CITY OF ALBUQUERQUE

RE: 220 Hazeldine SE
Grading & Drainage Plan
Engineer's Stamp Date: 04/16/20
Hydrology File: K14D222

RE: 220 Hazeldine
Grading & Drainage Plan (Stamp Date 3/26/20)
Hydrology File: K14D222

SW ELEGANT HOMES, LLC.
220 HAZELDINE AVENUE, S.E.
DUPLEX
ALBUQUERQUE, NEW MEXICO
MARCH, 2020

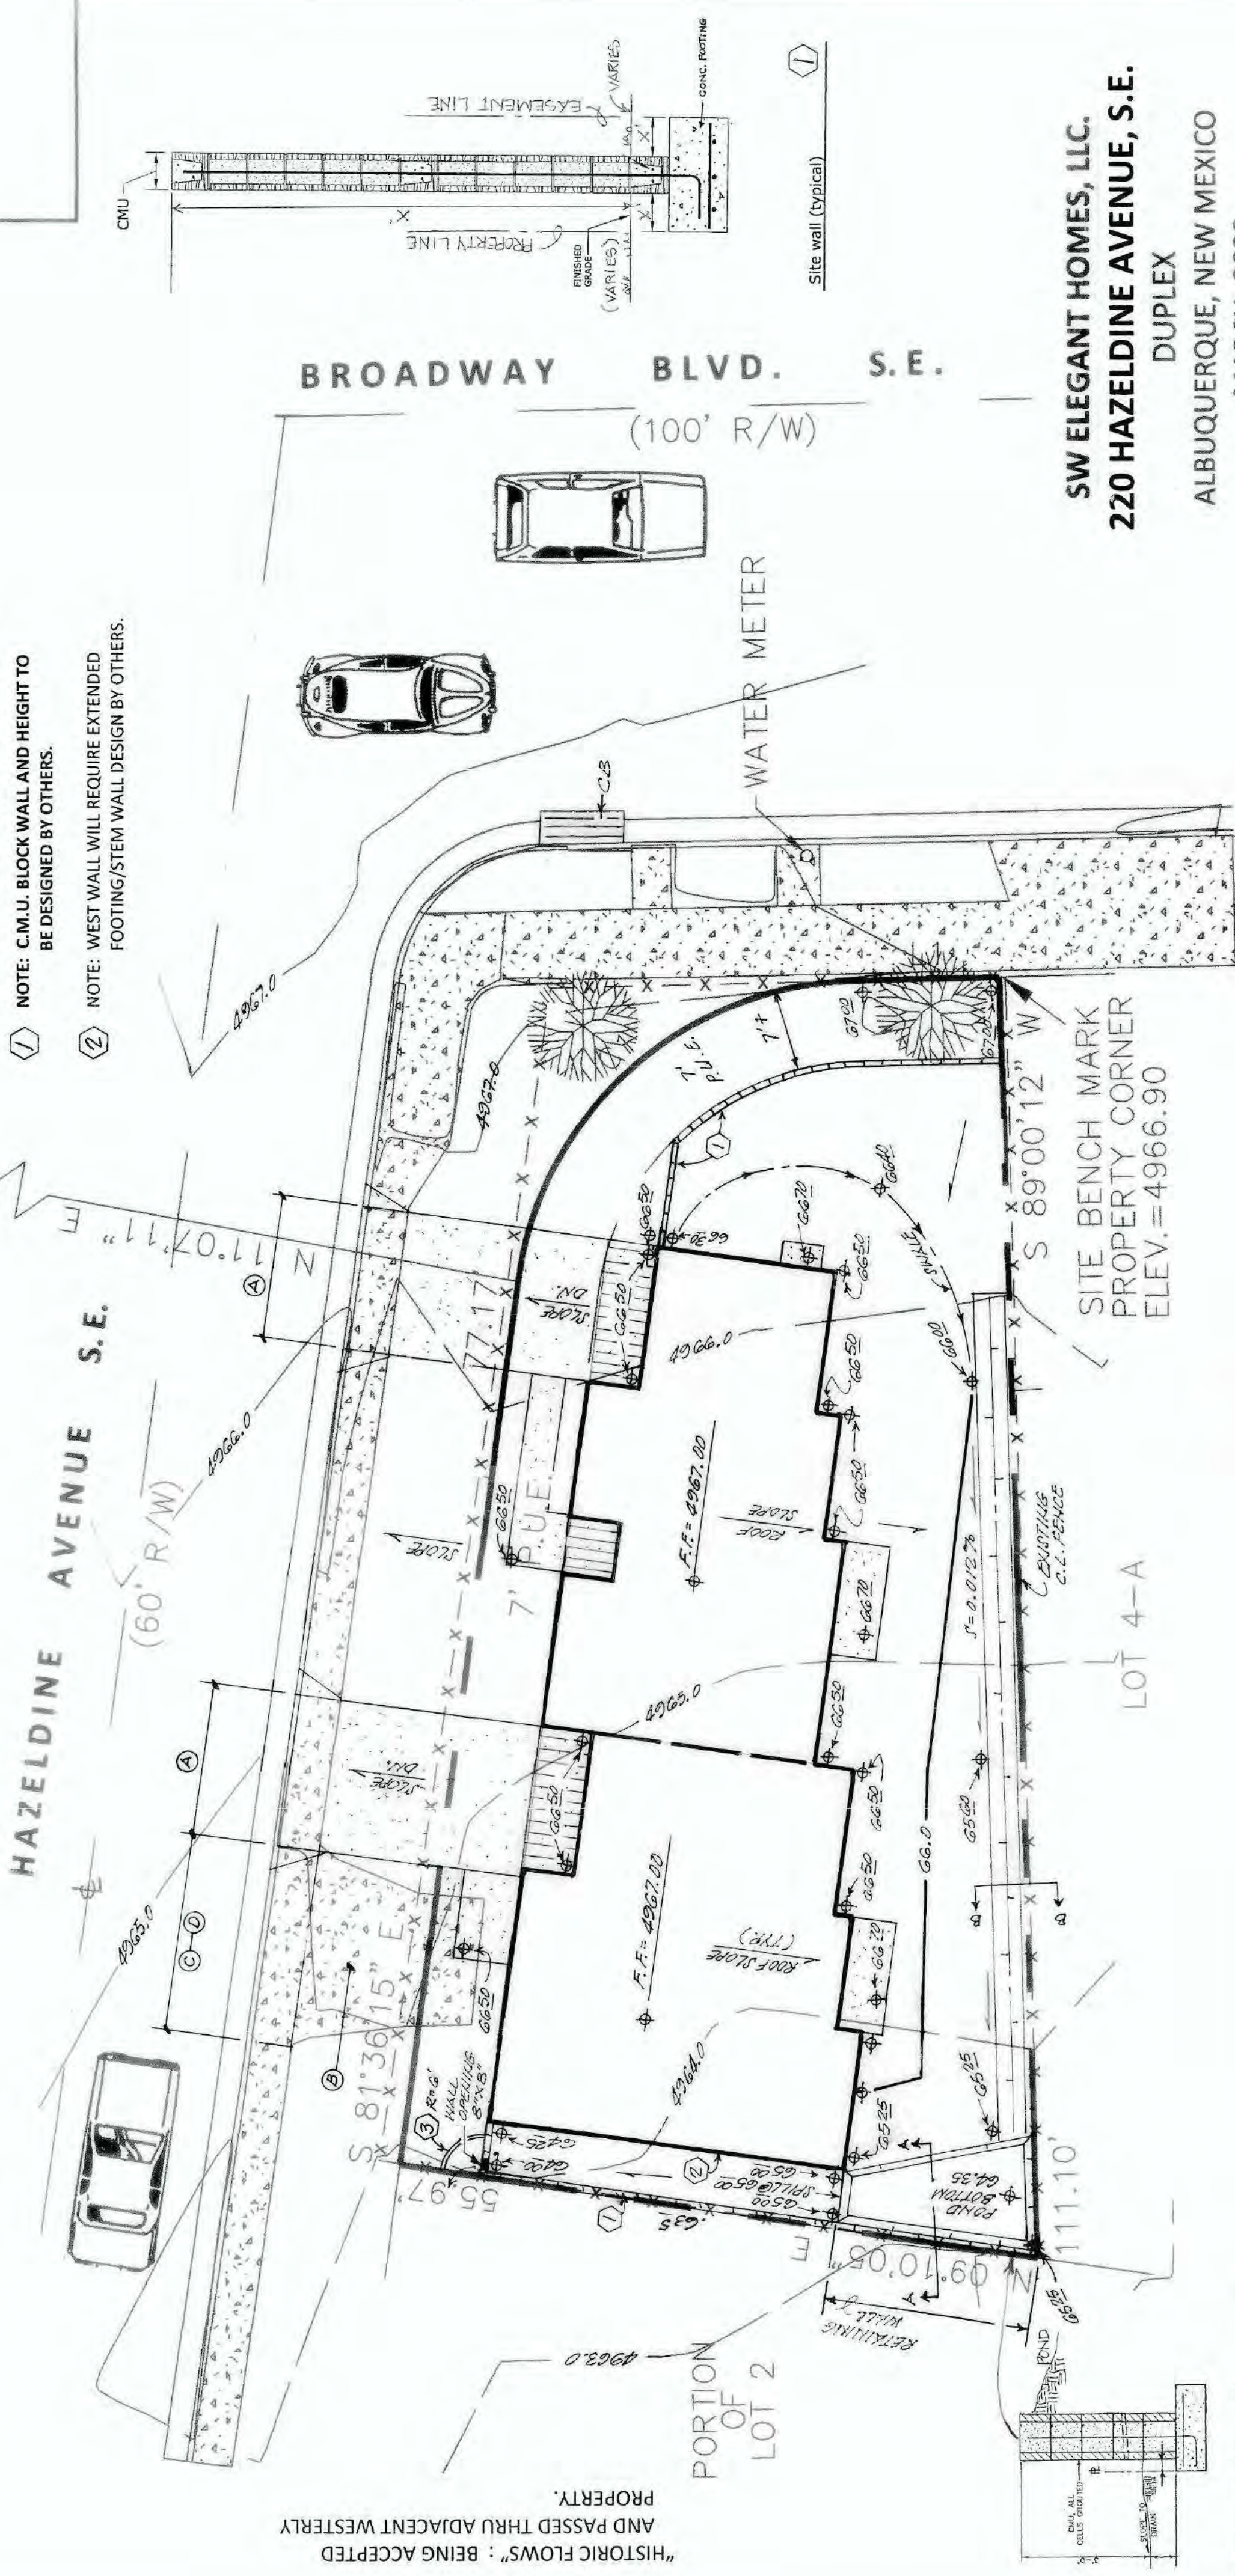
1. Please provide the weir calculations, per DPM Chapter 22.3.A.1, for the 3"x 6" opening in the CMU wall (turn block). A coefficient of 2.7 is typically used for the weir equation $Q = CLH^{2/3}$. *This information has been added to the plan for the 8" by 8" pond overflow wall opening. The 3" x 6" openings have been removed.*

WEIR CALCULATION:
8" X 8" OPENING IN CMU BLOCK WALL (1/2 BLOCK)
Weir
 $Q = C_d L \sqrt{2g} H^{3/2}$
Use 1/2 CMU opening
 $Q = (12.7)(0.57)(0.57)^{3/2}$
 $= 0.99 \text{ cfs capacity vs. } 0.25 \text{ cfs required}$

3'-0" RETAINING WALL DETAIL

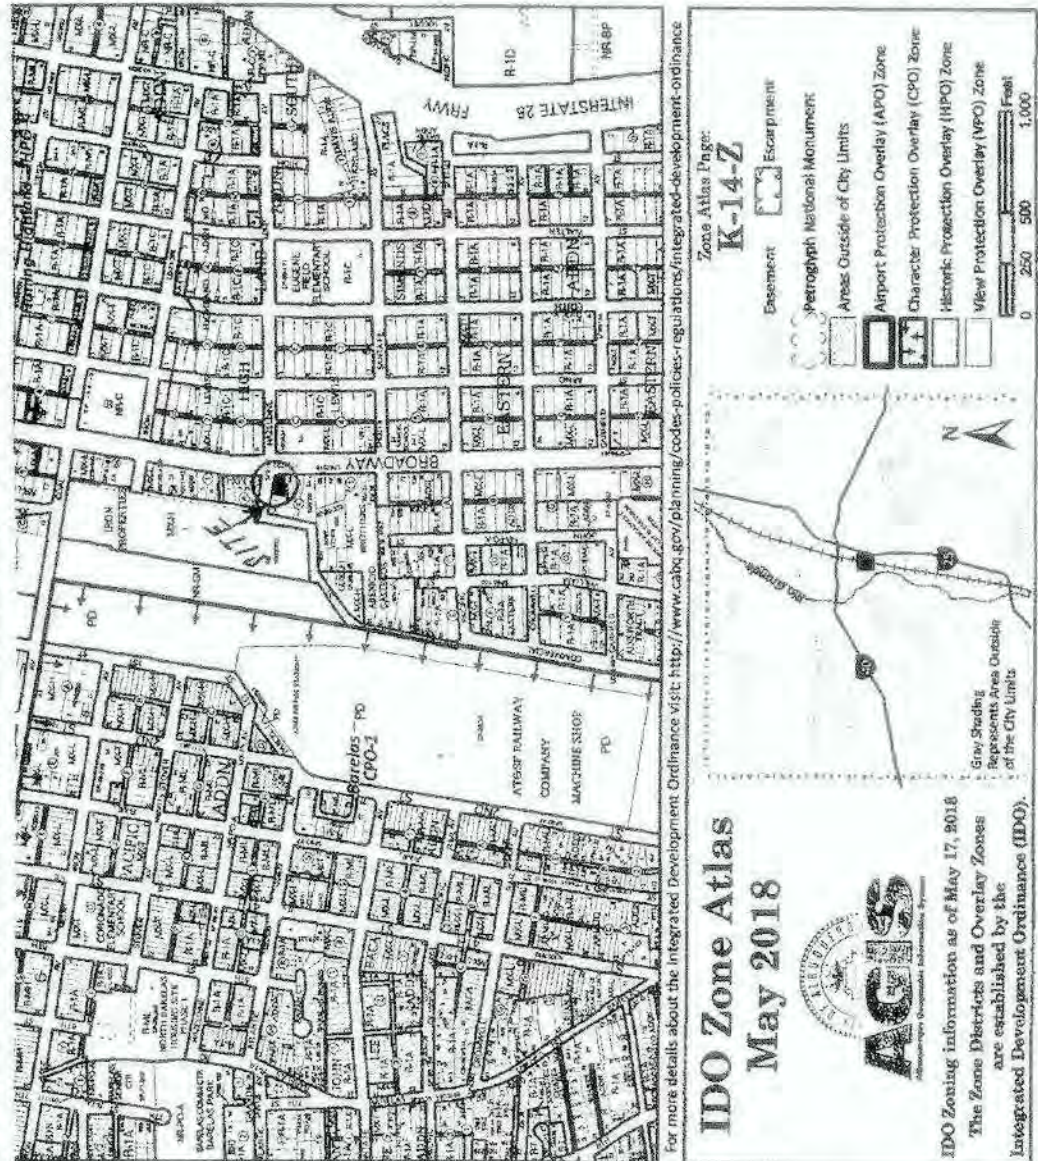
3. Provide sections through the proposed retaining walls along the Western property line and along Broadway, showing the footer, distance from the property/ROW lines, existing and proposed grades on either side of the wall. In accordance with DPM Ch.22, section 5 part B, grading and wall construction near the property line may not endanger adjacent property or constrain its use. *Sections have been provided. The wall along the western property line will be constructed on the property line.*

NOTE: WEST WALL WILL REQUIRE EXTENDED FOOTING/STEM WALL DESIGN BY OTHERS.
